State of New Mexico
Energy, Minerals and Natural ResourcesOIL CONSERVATION DIVISION
1220 South St. Francis Drive
Santa Fe, NM 87505FORM C-103
Revised March 25, 1999

SUNDRY NOTICES AND REPORTS ON WELLS (DO NOT USE THIS FORM FOR PROPOSALS TO DRILL OR TO DEEPEN OR PLUG BACK TO A DIFFERENT RESERVOIR. USE "APPLICATION FOR PERMIT" (FORM C-101) FOR SUCH PROPOSALS.)		WELL API NO. 30-025-06347

2. Name of Operator Apache Corporation		6. State Oil & Gas Lease No.
3. Address of Operator 2000 Post Oak Blvd., Ste. 100, Houston, Texas 77056-4400		7. Lease Name or Unit Agreement Name Northeast Drinkard Unit

4. Well Location Unit Letter <u>F</u> : <u>1973</u> Feet From The <u>North</u> Line and <u>1650</u> Feet From The <u>West</u> Line Section <u>2</u> Township <u>21S</u> Range <u>37E</u> NMPM <u>Lea</u> County		8. Well No. 118

P&A Proposal

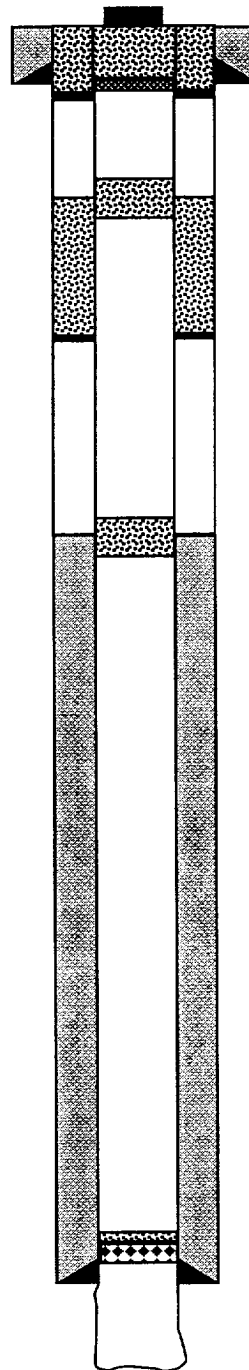
- Set CIBP @ 5650' and cap w/ 35' cement
PERF @ 2605'/50' ~~CEMENT OUT + 50' IN TAG @ 2505'~~
- ~~Spot cement plug 2500' - 2600' w/ 50 sx~~
1470' - 1370'
- Spot cement plug 920' - 1020' w/ 50 sx ~~Tag top of plug~~
- Perforate 4-1/2" casing @ 375'. Set cement retainer @ 350'. Cement squeeze behind 4-1/2" casing circulating to surface inside and outside casing
- Install P&A marker
